Single Engine

Service Bulletin

SEB04-1
Revision 1

AILERON HINGE BRACKET INSPECTION

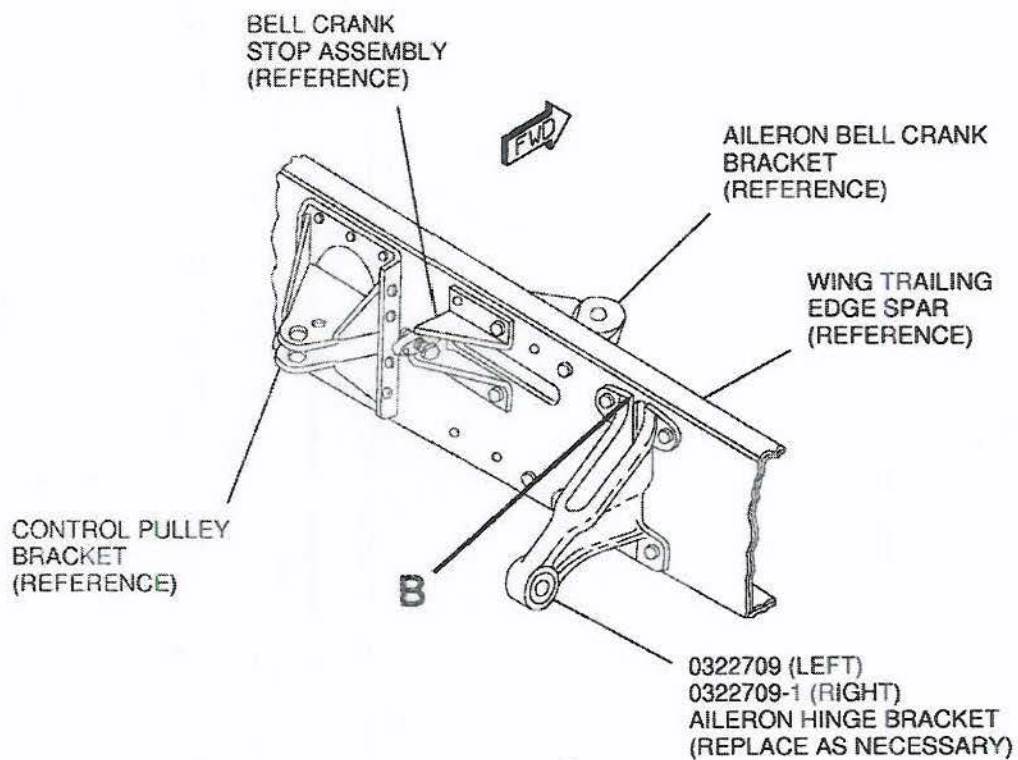
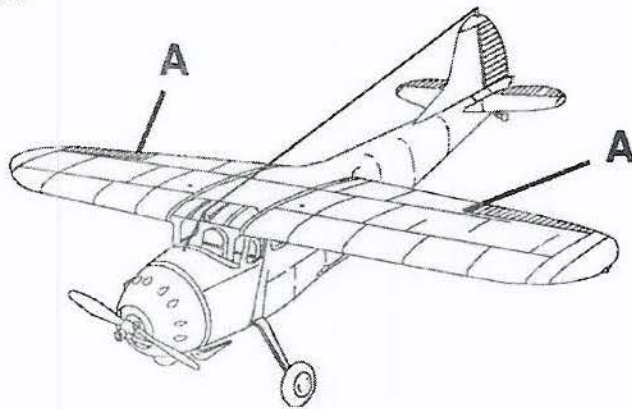
A. (Refer to Figure 1, Sheet 2.) If a new hinge bracket is being installed, the 0322715-1 Aileron Fillet may need to be trimmed so the new hinge bracket will fit to the rear wing spar correctly. (Refer to the Cessna 190 & 195 Parts Catalog.)

B. Install the aileron hinge brackets to the rear wing spar with the kept bolts and new MS20365-1032 Nuts, and torque each nut to 25 inch-pounds.

Figure 1. (Sheet 1)

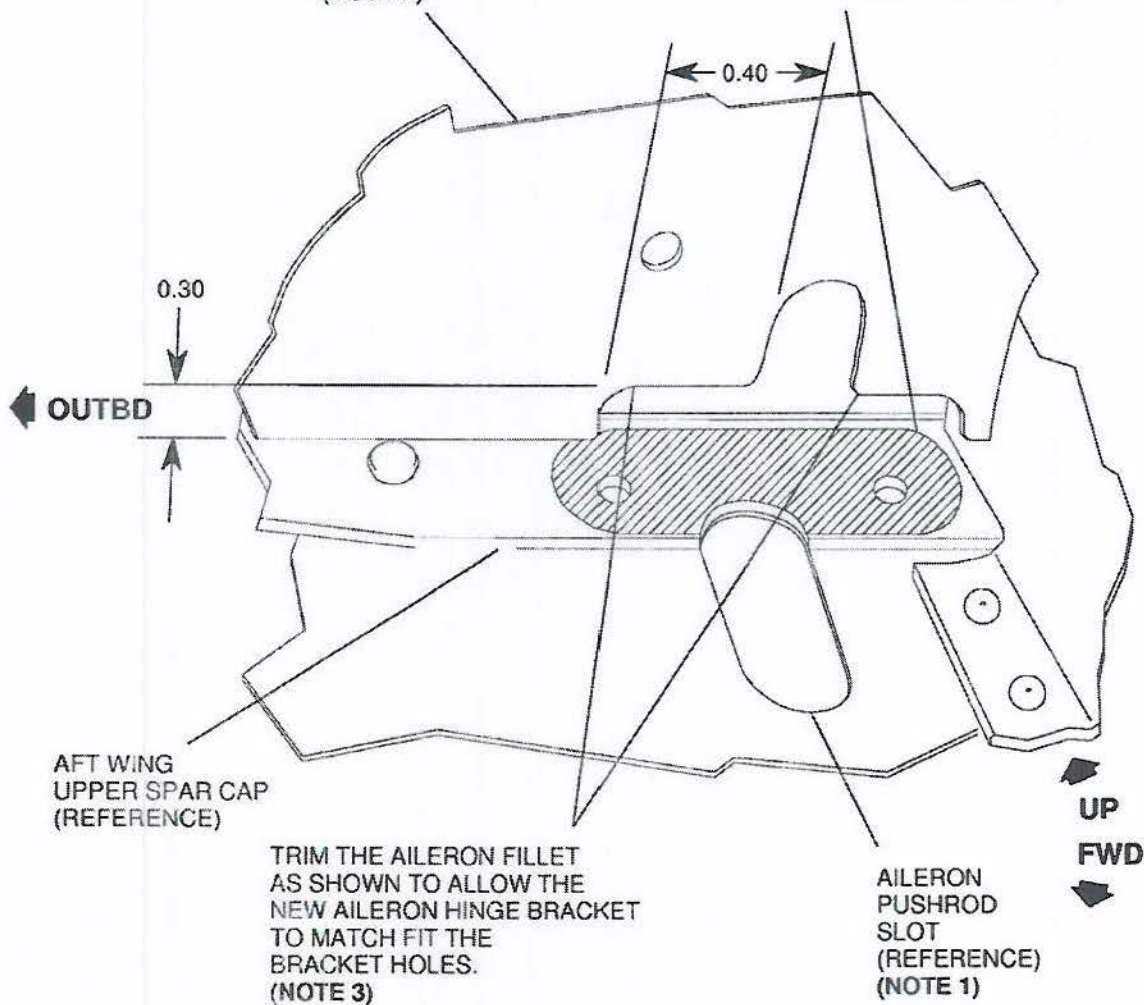
7. Remove the paint from the 0322709 and 0322709-1 Aileron Hinge Brackets.
8. Do a visual inspection of the 0322709 and 0322709-1 Aileron Hinge Brackets for corrosion and cracks.

NOTE: The original and older replacement inboard aileron hinge brackets were made of Magnesium which has a greater potential to corrode or crack than aluminum.

- A. Look on the aileron hinge brackets for identification as follows:
 - (1) Magnesium forged brackets have a 0822605-497 or a 0322707-2 mark on them.
 - (2) Aluminum forged brackets have a 0822605-499 mark on them.

- B. If corrosion or cracks are found on the 0322709 and/or 0322709-1 Aileron Hinge Bracket, replace the bracket with a new Aluminum aileron hinge bracket as necessary.

NOTE: The new replacement 0322709 and 0322709-1 Aileron Hinge Brackets are Aluminum.

(1) Apply Alodine and corrosion resistant primer to the new aileron hinge bracket part and paint to match the airplane finish.
